Memorandum to the City of Markham Committee of Adjustment

File: A/035/24
Address: 56 Ladyslipper Court, Markham (Thornhill)
Applicant: Mehdy Ajvand
Hearing Date: Wednesday, August 14, 2024

1 SITE PLAN

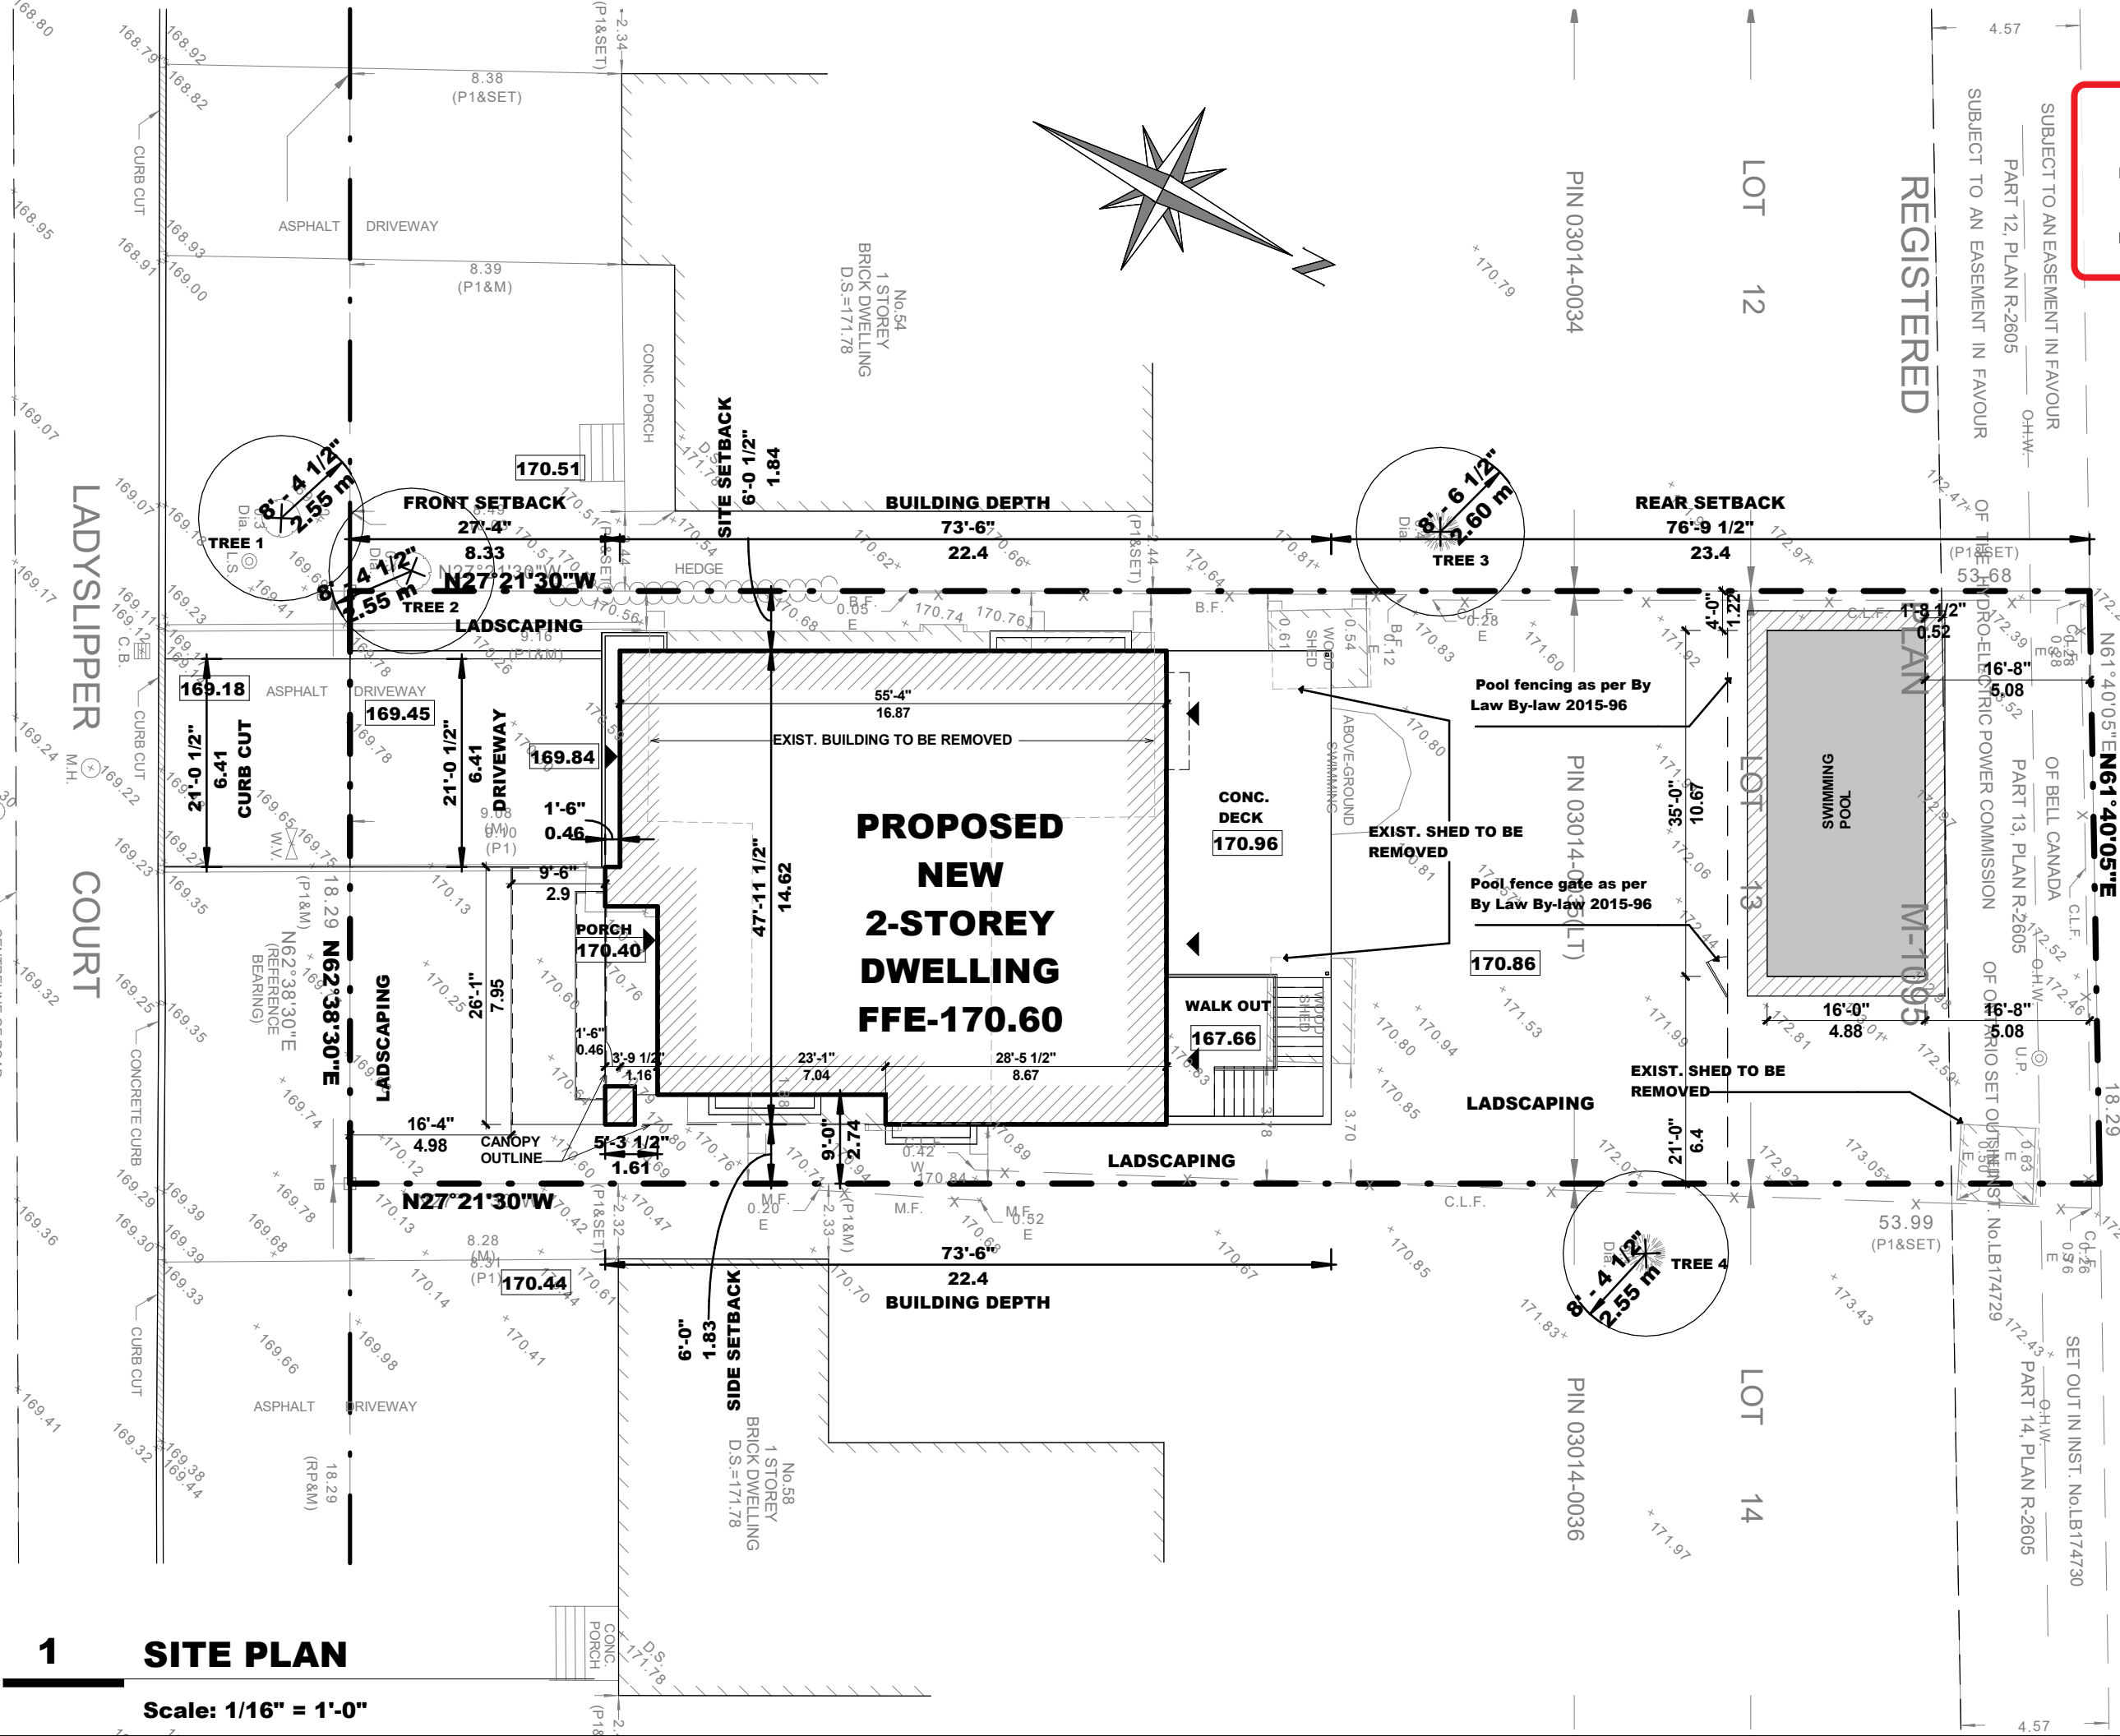
The Owner is requesting relief to permit a combined interior side yard on both sides of 3.67 metres (12.04 feet), whereas a combined interior side yard of 4.0 metres (13.12 feet) is required. This represents a combined interior side yard setback reduction on both sides of 0.33 metres (1.08 feet).

The intent of the side yard setback requirements is to provide adequate spacing between dwellings for drainage and appropriate building massing. Staff are of the opinion that the reduced combined interior side yard setbacks will provide an adequate area for drainage and will not adversely impact the abutting properties.

The Owner is requesting relief to permit a maximum building depth of 22.40 metres (75.23 feet), whereas a maximum building depth of 16.80 metres (55.12 feet) is permitted. This represents an increase of approximately 5.60 metres (18.37 feet).

Building depth is measured based on the shortest distance between two lines, both parallel to the front lot line, one passing through the point on the dwelling which is the nearest and the other through the point on the dwelling which is the farthest from the front lot line.

The proposed building depth variance includes a rear covered canopy/concrete deck and a front covered porch which adds approximately 5.54 metres (18.17 feet) to the overall depth of the building. Excluding the rear covered canopy/concrete deck and a front covered porch, the proposed building depth is 16.87 metres (55.34 feet). This represents an increase of 0.07 metres (0.23 feet), which is generally consistent with what the By-law permits.

Staff are of the opinion that the proposed building depth is minor in nature, will have limited impact and therefore have no concern with the requested variance.

1 SOUTH ELEVATION

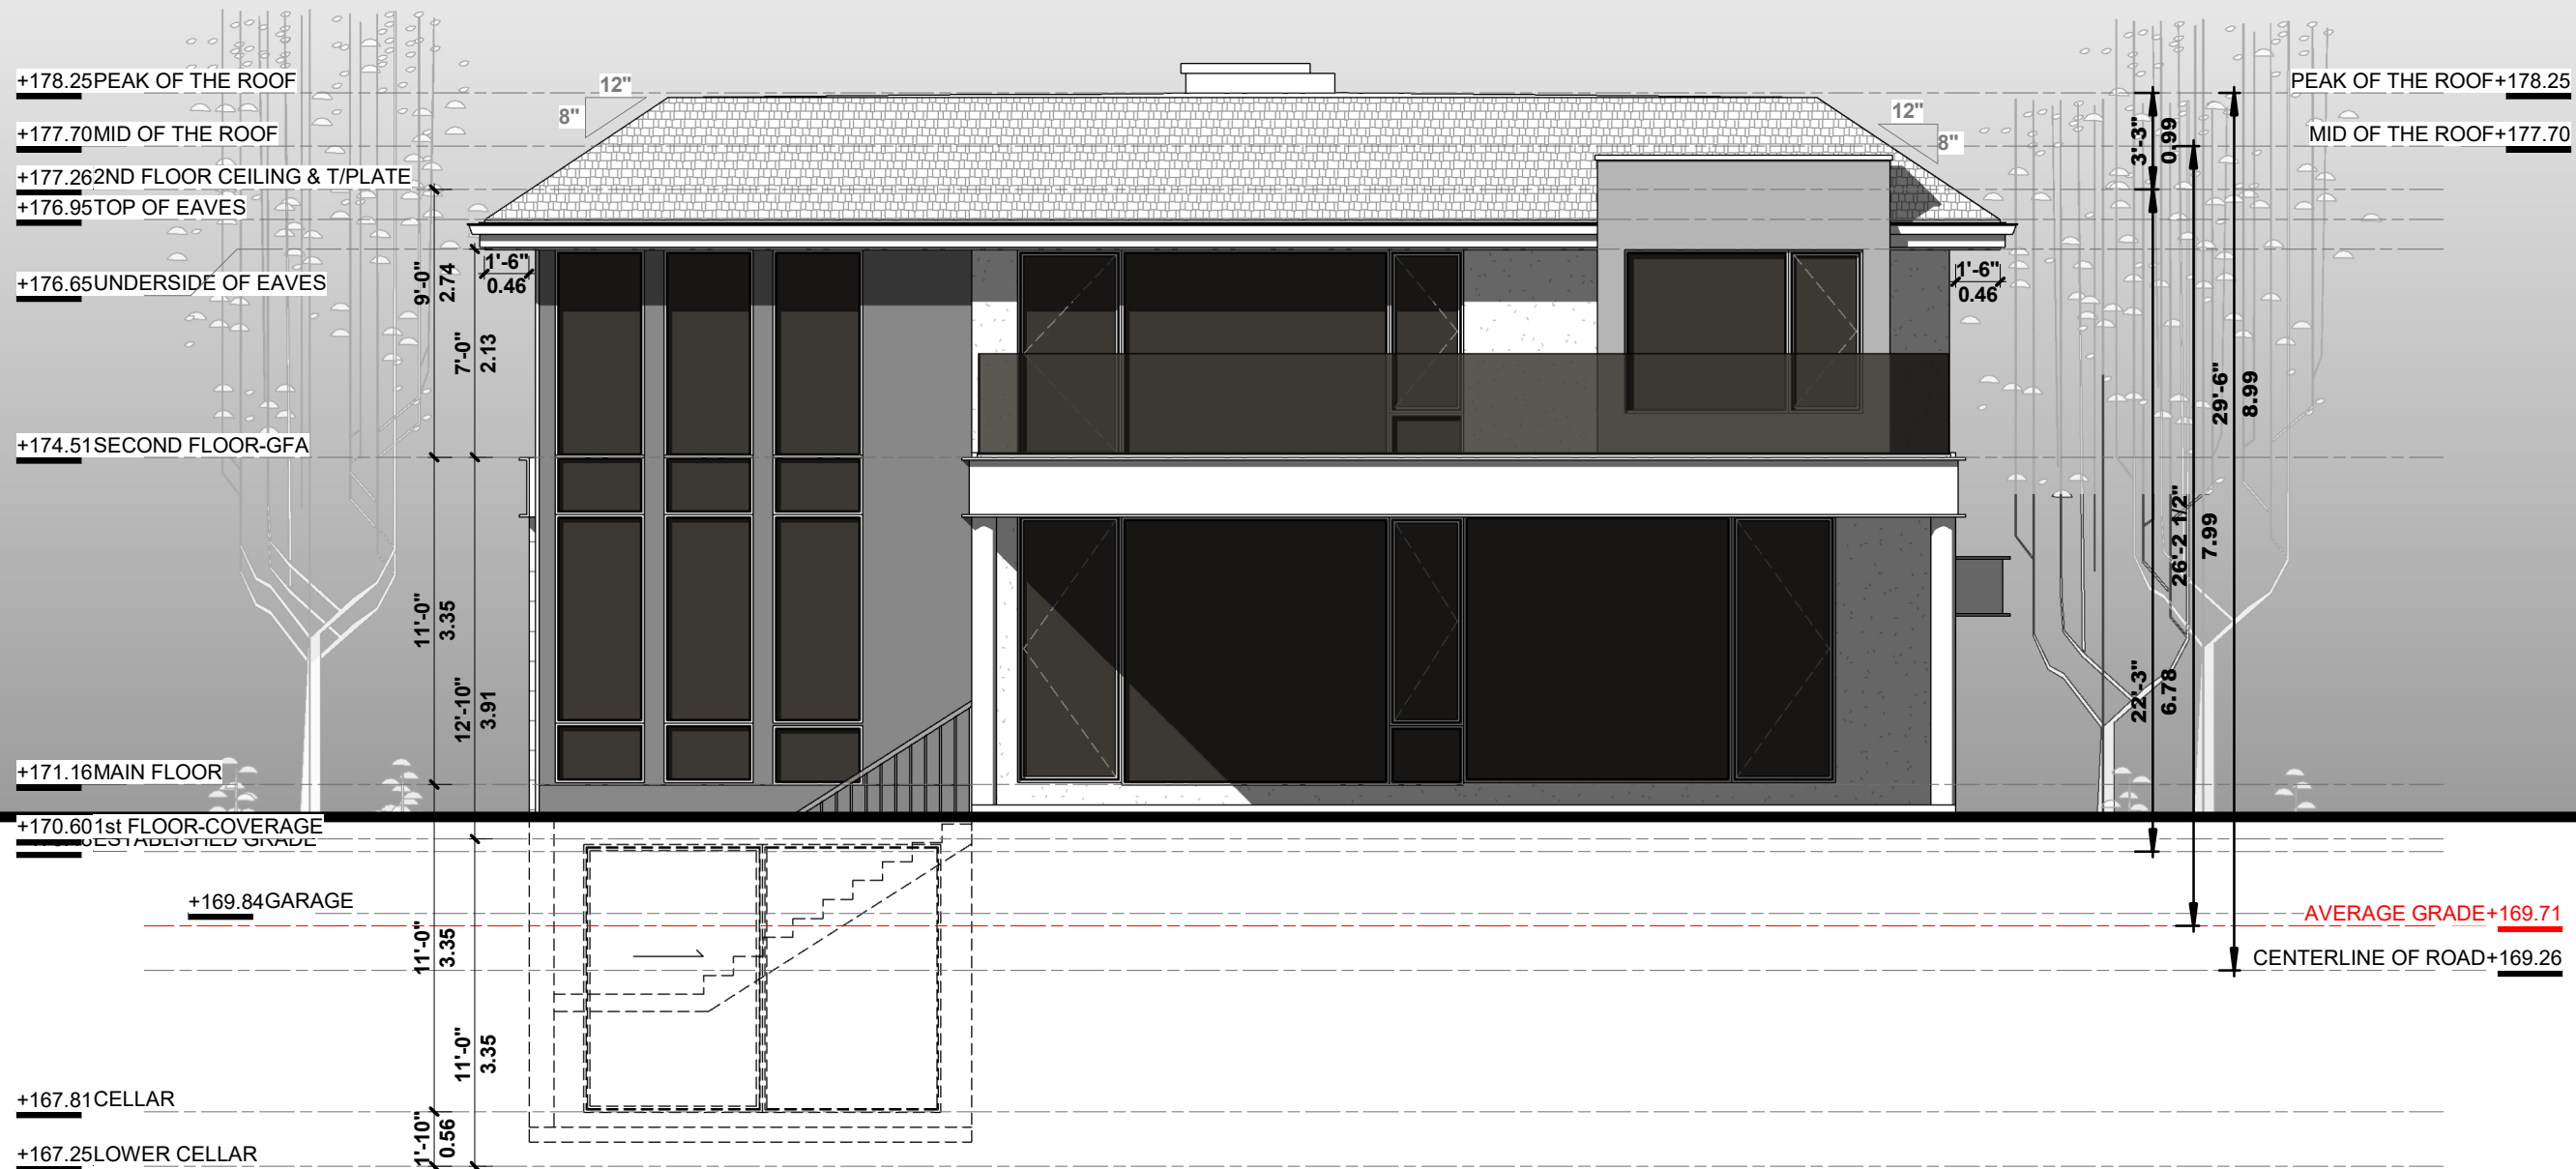
The Owner is requesting to permit a maximum distance of the main building building from the established building line for any storey above the first storey of 16.80 metres (55.12 feet), whereas a maximum distance of 14.5 metres (47.57 feet) for any storey above the first from the established building line is permitted. This represents an increase of 2.30 metres (7.5 feet).

The intent of the maximum distance from the established building line for any storey above the first includes, but is not limited to, consideration for sunlight/shadowing, and the built form and character of the neighbourhood. Staff are of the opinion that the proposed extension to a distance of 16.80 metres (55.12 feet), for the second storey will have limited impact on the streetscape and neighbouring properties as the setbacks are generally maintained and the two storey scale is consistent with other infill developments in the area.
